Memorandum

RE: MMU Comments on Independent Consultant Initial Draft ICAP Demand Curve Reset Report and Recommendations

Chart 1: B-Rated Bond Yield, July 2019 to June 2020

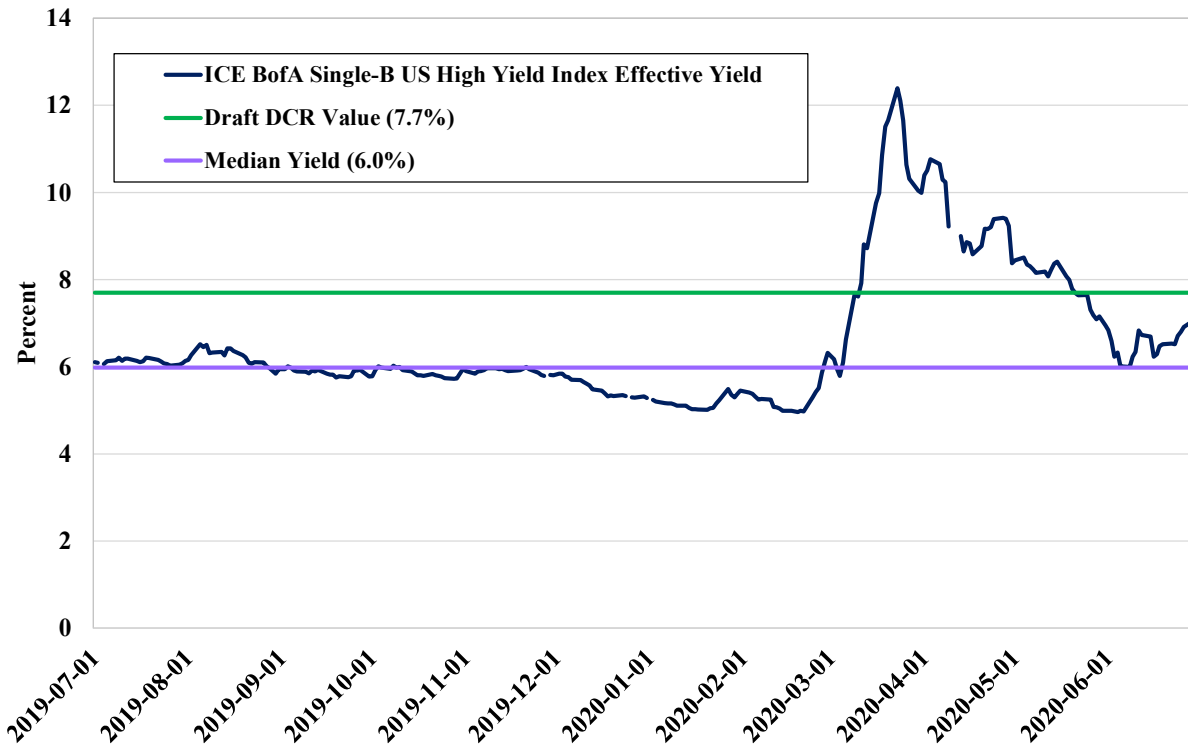
the Federal Reserve Bank of St. Louis for the year from July 2019 through June 30, 2020. Yields began to rise sharply in late February and remained elevated in April and May. Yields then fell close to pre-COVID levels before moving up again on news of a surge in new cases of the virus, with a median of 6.5 percent for the month of June.

The purpose of this analysis is not to suggest that only the most recent yields during June 2020 should be used. Rather, it is to highlight that recent trends should provide grounds for extreme caution in considering how debt yields during the first half of this year will relate to the cost of borrowing for the entirety of the 2021-2025 demand curve reset period. A principled approach to establishing all demand curve parameters is to seek values that reflect a reasonable expectation of the parameter over the reset period. Such an approach to calculating the cost of debt (e.g., a rule-based method such as using the median over a significant period of time) will avoid giving undue weight to short-term market fluctuations.

Median yields over these periods are consistent with an estimated cost of debt between 6.0 and 6.5 percent. We recommend that the consultants propose a cost of debt in this range based on historical borrowing costs over a period that includes data since the onset of COVID-19 but does not assign it disproportionate weight.
